Work Order ID 85322

Item Name: Crosstube Turning Detail

DRAWING NO. D407-667-245	TITLE CROSSTUBE ASSY (407 HIGH AFT)	REV. F	DART AEROSPACE LTD ENGINEERING ORDER		D.E.O. NO. D407-667-245-F-1	SHEET NO. SHEET 1 OF 2	SCALE NTS
DRAWN <i>3</i>	CHECKED <i>90</i>	MFG. APPR. <i>E</i>	APPROVED <i>140</i>	DE APPR. <i>14</i>			
DATE 11.04.08	DATE 11.04.12	DATE 11.04.12	DATE 11.04.12	DATE 11.04.12	DATE 11.04.12

DRAWING NO. D407-667-245	TITLE CROSSTUBE ASS'Y (407 HIGH AFT)	REV. F	DART AEROSPACE LTD ENGINEERING ORDER		D.E.O. NO. D407-667-245-F-2	SHEET NO. SHEET 1 OF 1	SCALE NTS
DRAWN 92	CHECKED ASS	MFG. APPR. E	APPROVED MP		DE APPR. H		
DATE 11.09.07	DATE 11.09.19	DATE 11.09.19	DATE 11.09.19		DATE 11.09.19

DRAWING NO. D407-667-245	TITLE CROSSTUBE ASSY (407 HIGH AFT)	REV. F	DART AEROSPACE LTD ENGINEERING ORDER	D.E.O. NO. D407-667-245-F-1	SHEET NO. SHEET 2 OF 2	SCALE NTS
DRAWN	CHECKED	MFG. APPR.	APPROVED	DE APPR.		
DATE 11.04.08	DATE 11.04.11	DATE 11.04.12	DATE 11/04/12	DATE 11.04.12

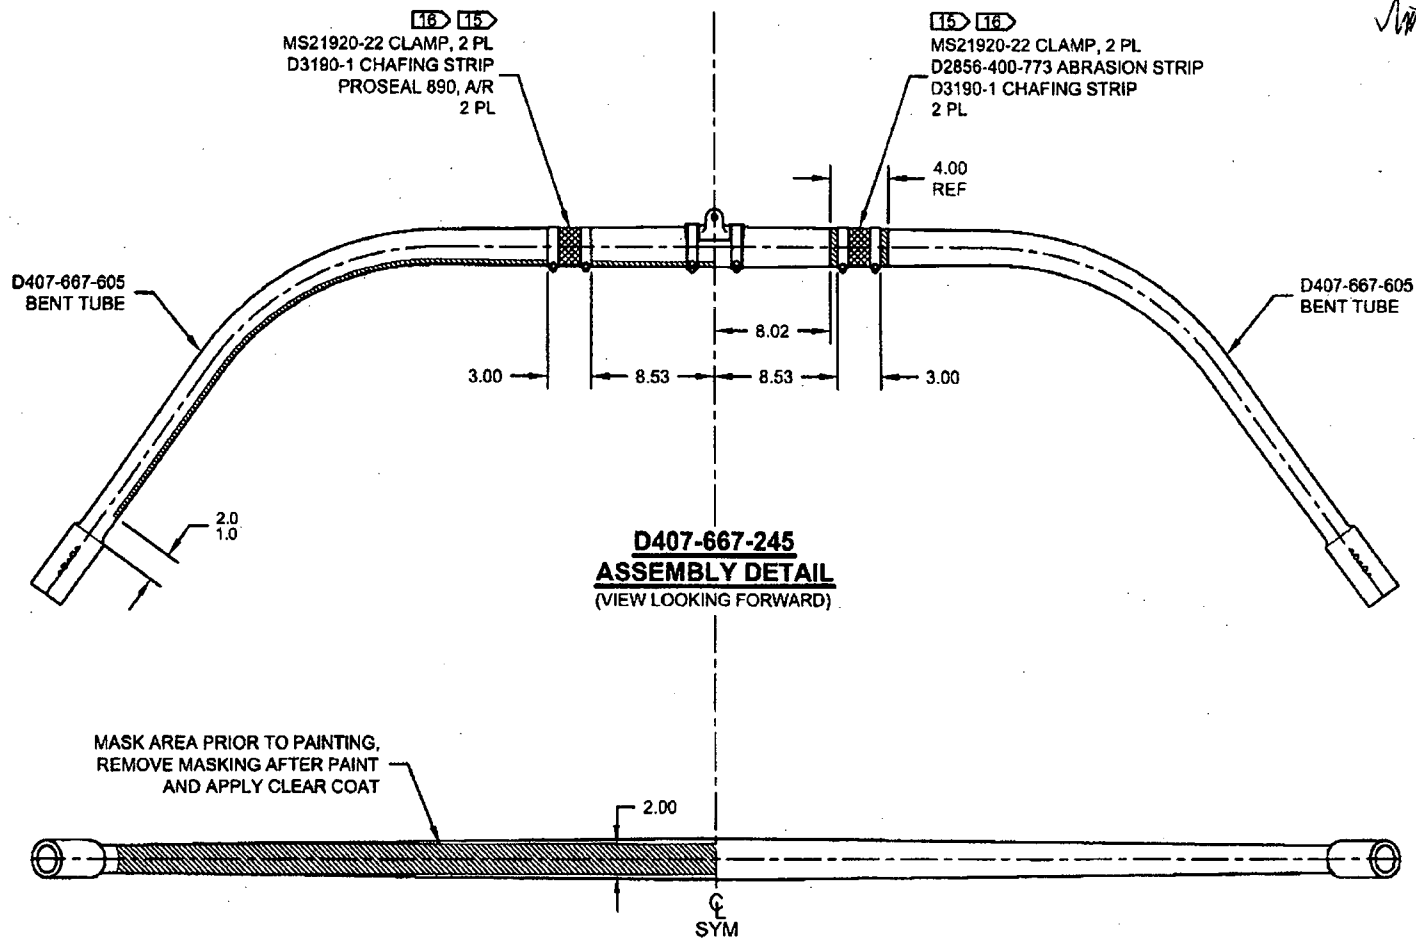
REMOVED ABRASION STRIP IN FAVOR OF A THIN LAYER OF PROSEAL 890.

NOTES 2 AND 15, SHEET 1 ARE AMENDED AS FOLLOWS:

IS:

WAS:
